Access Compliance Report

Public Rights-of-Way

(Curb Ramps)

Intersection ID: 52765	Main Street: SHOPTON_RD	Cross Street: OUTLETS_BV	Location: SE
ADA ID: 34A430C42807	Ramp Type: PerpDiag	Initial Pass/Fail: Fail	Overall Compliance: No
Severity Score: 33.75			
Codes/Mitigation Info/Possible Solution		Field Measurements/Component Compliance

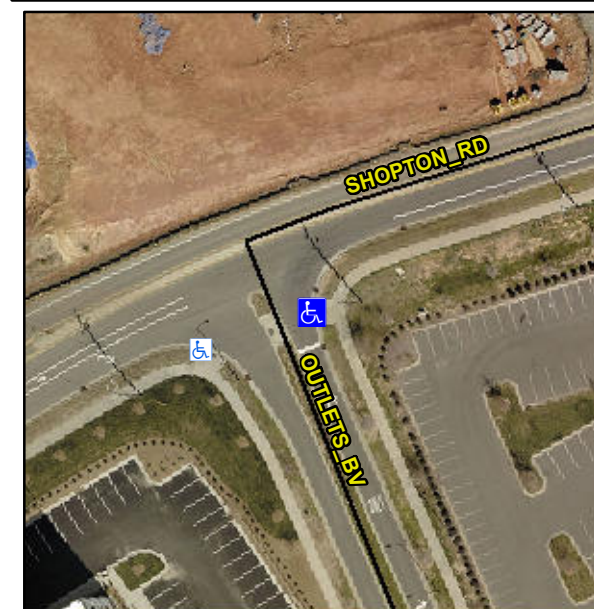
Not Found, R304.5.1, R304.5.3

Compliance	Description	Data	Compliance	Description	Data
N/A	Ramp Length (in)	98.0	Yes	Ramp Slope (%)	6.3
No	Ramp Width (in)	42.0	No	Ramp XSlope (%)	7.6
N/A	Flare Type LT	N/A	N/A	Flare Type RT	N/A
N/A	Flare Slope LT (%)	N/A	N/A	Flare Slope RT (%)	N/A
N/A	Flare Traversable LT?	N/A	N/A	Flare Traversable RT?	N/A
N/A	Landing Length (in)	N/A	N/A	DWS Provided?	N/A
N/A	Landing Width (in)	N/A	N/A	DWS Contrast?	N/A
N/A	Landing Slope (%)	N/A	N/A	DWS Length (in)	N/A
N/A	Landing X Slope (%)	N/A	N/A	DWS Full Width?	N/A
N/A	Landing Curb? (Y/N)	N/A	N/A	DWS Offset (in)	N/A
N/A	Shared Landing?	N/A			
N/A	Gutter Ponding?	N/A	N/A	Gutter Slope (%)	N/A
N/A	Gutter Lip Ht (in)	N/A	N/A	Gutter X Slope (%)	N/A
N/A	Painted X Walk1?	No	N/A	Painted X Walk2?	No
	X Walk 1 Direction	To W		X Walk 2 Direction	To N
N/A	X Walk 1 Width (in)	N/A	N/A	X Walk 2 Width (in)	N/A
	X Walk 1 Slope (%)	6.0		X Walk 2 Slope (%)	3.3
	X Walk 1 X Slope (%)	2.8		X Walk 2 X Slope (%)	5.8

Remove & Replace Curb Ramp With Two New Directional Ramps or Equivalent.
